MARTIAL COTTLE PARK

STATE PARK GENERAL PLAN/COUNTY PARK MASTER PLAN FINAL EIR

**STATE CLEARINGHOUSE #2010022006
FINAL
CERTIFIED FEBRUARY 8, 2011**

FIGURE 3 - 5
 CIRCULATION PLAN

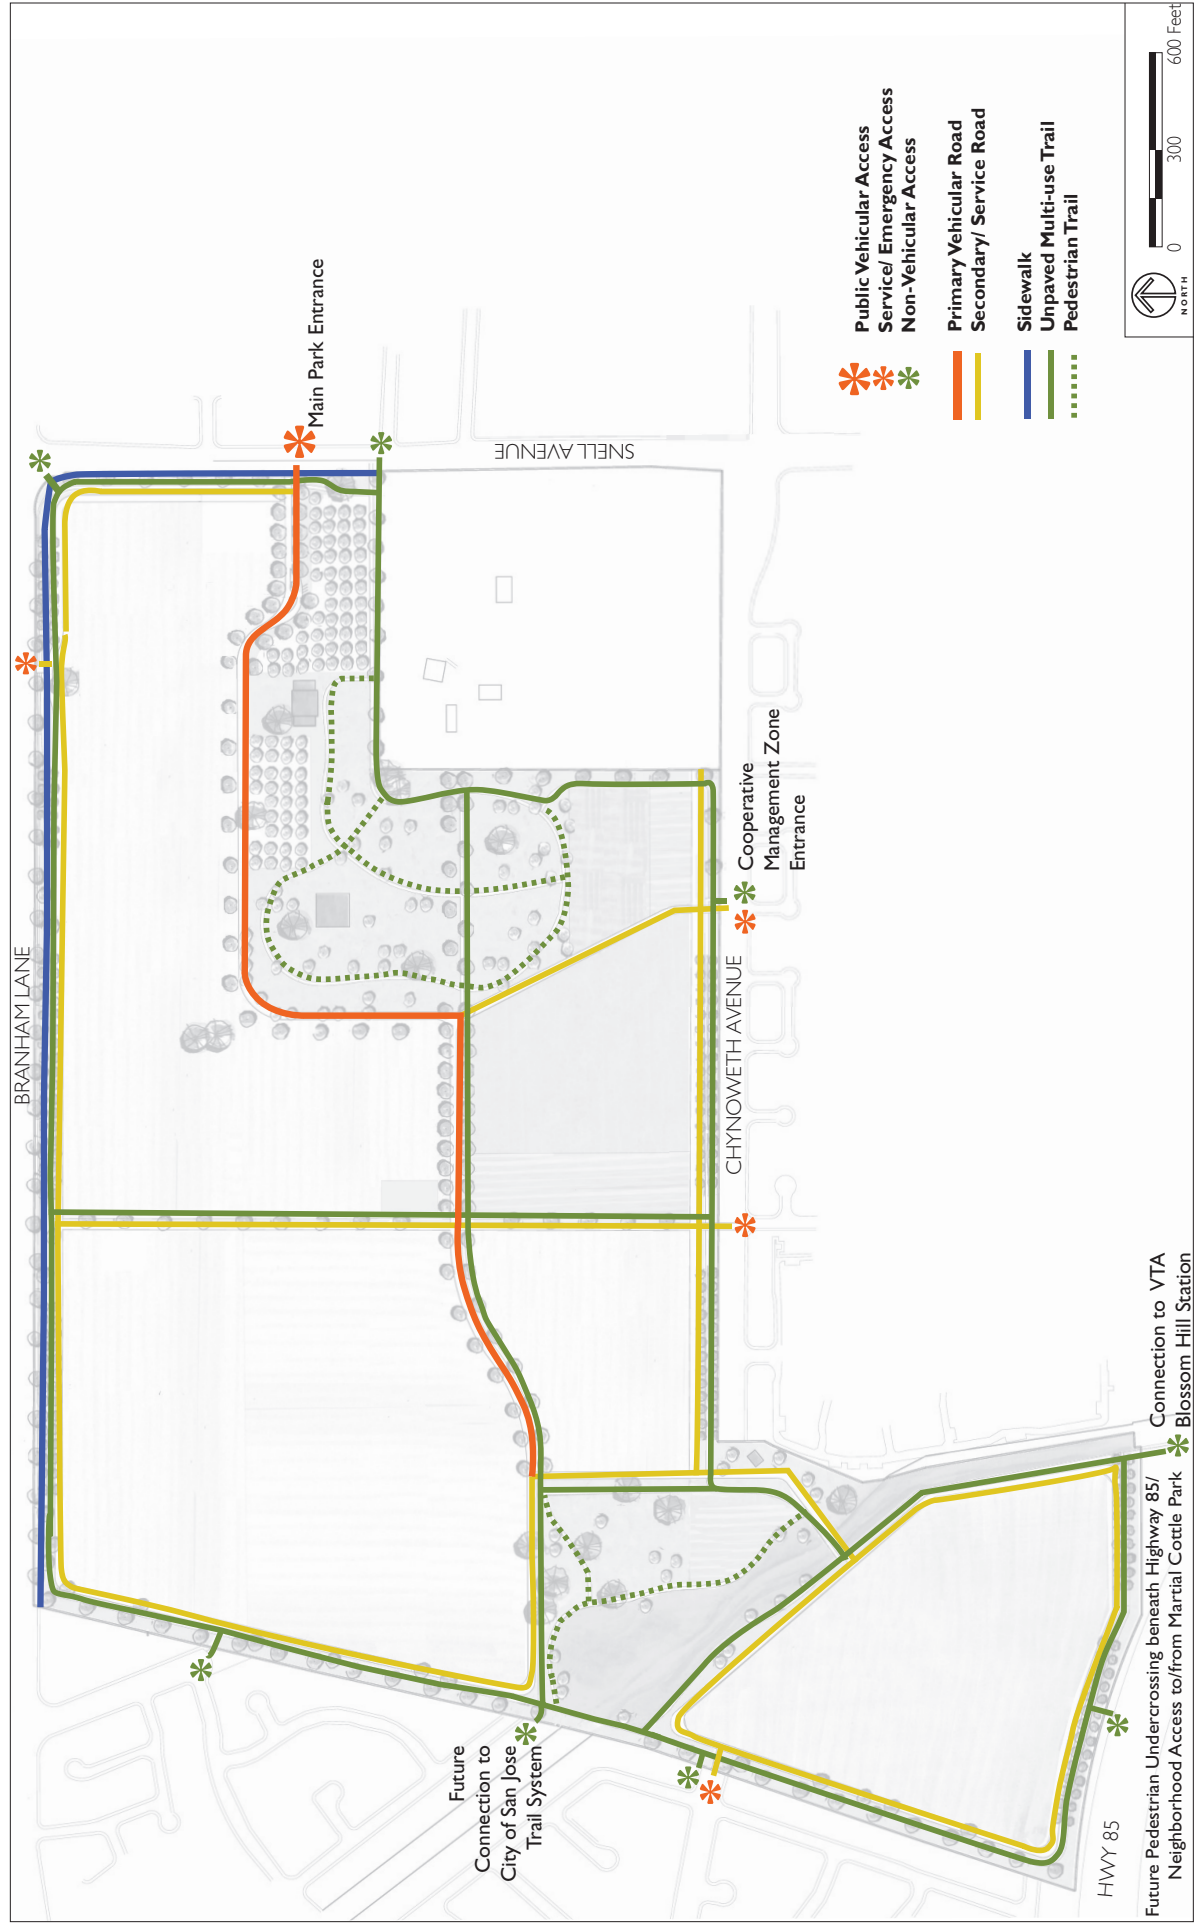
Figure 3-5 on page 3-21 of the Draft EIR is hereby replaced with the figure on the following page. Revisions to Figure 3-5 include:

- ◆ Addition of a non-vehicular access point north of Canoas Creek channel for a future connection to the City of San Jose trail system.
- ◆ Amending the label for “Future Undercrossing/Connection to Blossom Hill Road” to “Future pedestrian undercrossing beneath Highway 85/ neighborhood access to/from Martial Cottle Park.”

Figure 3-5 shows locations of anticipated bicycle and pedestrian entrances to the park. The figure shows a future connection to a future City of San Jose trail system (Canoas Creek Trail). However, the anticipated future alignment of the City's trail will follow the creek channel and not Chynoweth Avenue as the figure in the Draft EIR suggests. We request that the "Future Connection to City of San Jose Trail System" be shifted northward to accurately reflect the planned alignment along the Canoas Creek channel. Offering access to the neighborhood street as shown is beneficial so we requested that it be identified as "Future Connection to Chynoweth Avenue Bike Lanes."

The project would include three ~~new~~ bridges: a new pedestrian/bicycle crossing along the western perimeter of the project site, over Canoas Creek; ~~one to replace~~ modification, upgrade, or replacement of the existing vehicular bridge over Canoas Creek, near the on-site pump house; and a new pedestrian/bicycle crossing over Canoas Creek to the Blossom Hill light rail station. The bridges will be designed so that there are no impacts to the channel capacity of Canoas Creek or the SCVWD’s access along the top of the bank.

The project would also include a future pedestrian undercrossing beneath Highway 85 to provide neighborhood access to and from the Park. The undercrossing would provide another walk-in neighborhood access point into the Park, from the neighborhoods south of Highway 85. The pedestrian undercrossing would be part of subsequent phases of the Park development and would include off-site improvements.

FIGURE 4.10-1
 MEAN DAILY FLOW FOR CANOAS CREEK

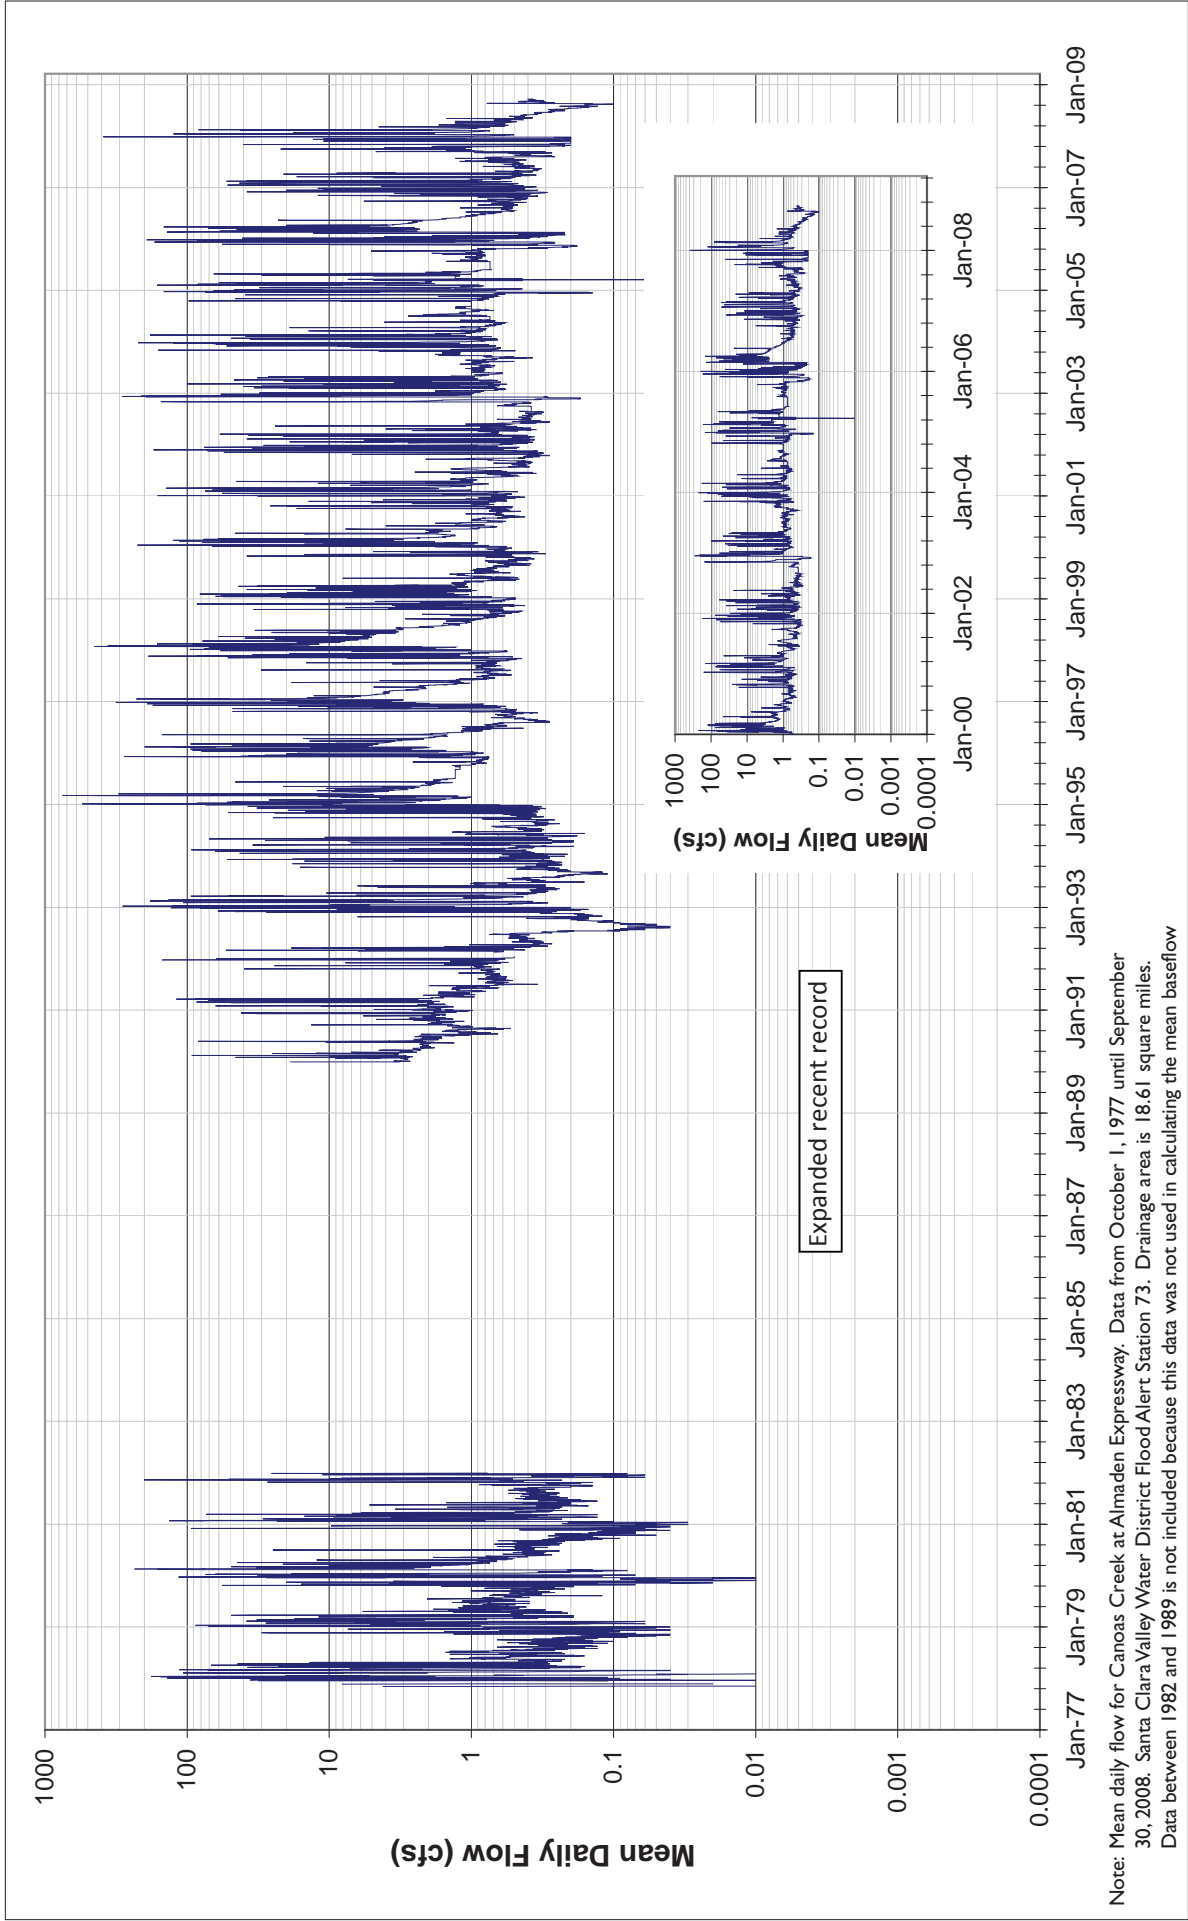
13. Data for the 1980s is not included in Figure 4.10-1, and there is no note on the figure indicating why this data is not shown.
14. Page 4.10-14 states that "the lower segments of the creek convey high volumes of treated effluent from wastewater treatment facilities to the San Francisco Bay; the flow regime and quality of water in these segments is dominated by the treated effluent releases." None of the three wastewater treatment plants located in the northern part of the County discharge to the Guadalupe River or its tributaries.

Figure 4.10-1, “Mean Daily Flow for Canoas Creek” on page 4.10-15 of the Draft EIR is hereby replaced with the revised figure on the following page.
